Application Serial No. 10/582,700  
Reply to Office Action dated October 28, 2008  
Amendment dated February 24, 2009

**AMENDMENTS TO THE DRAWINGS**

### **REMARKS**

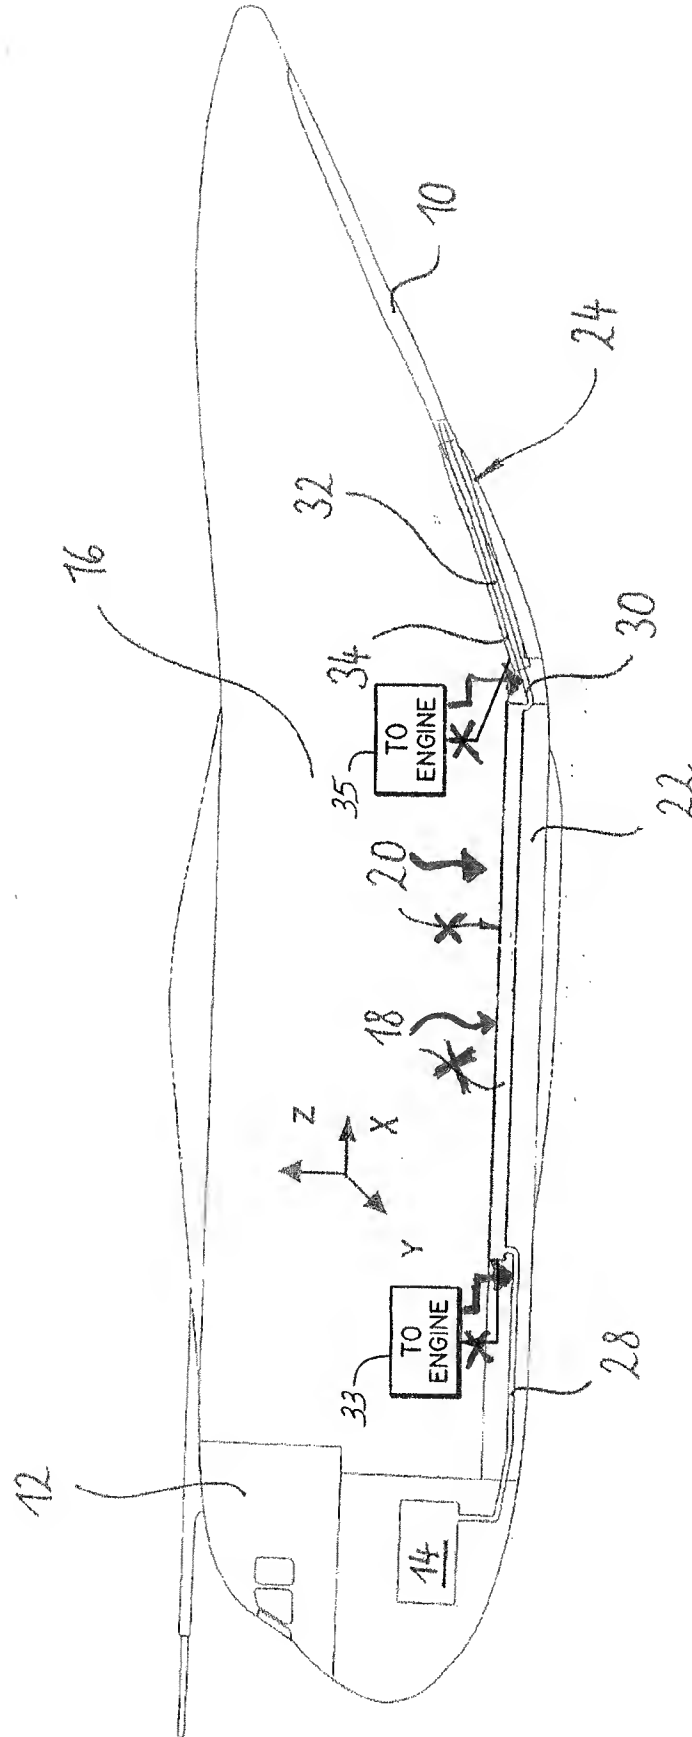
The Office Action objected to the addition of feed lines (33, 35) in FIG. 1 because the arrows drawn extended from the floor and cargo door to the engine. The arrows have now been amended in the replacement drawing sheets to indicate the proper direction of flow of hot engine bleed air. As discussed previously, these features are supported in the original Specification. For at least these reasons, Applicants respectfully request that this objection be withdrawn.

The Office Action further objected to the addition of reference numeral 43 to reference heating mats in FIG. 2. FIG. 2 in the replacement drawing sheets has been amended to clearly distinguish the rigid insulation (40) and the heating mats (43). The

The Office Action objected to the addition of ventilator (39) in FIG. 3. To dispel any confusion regarding the schematic representation of the ventilator, FIGS. 2 and 3 have been amended in the replacement drawing sheets to remove the arrowheads. Additionally, the ventilator (39) has been positioned behind the direction of flow through the hollow chambers (26) in amended FIG. 2. For at least these reasons, Applicants respectfully request that this objection be withdrawn.
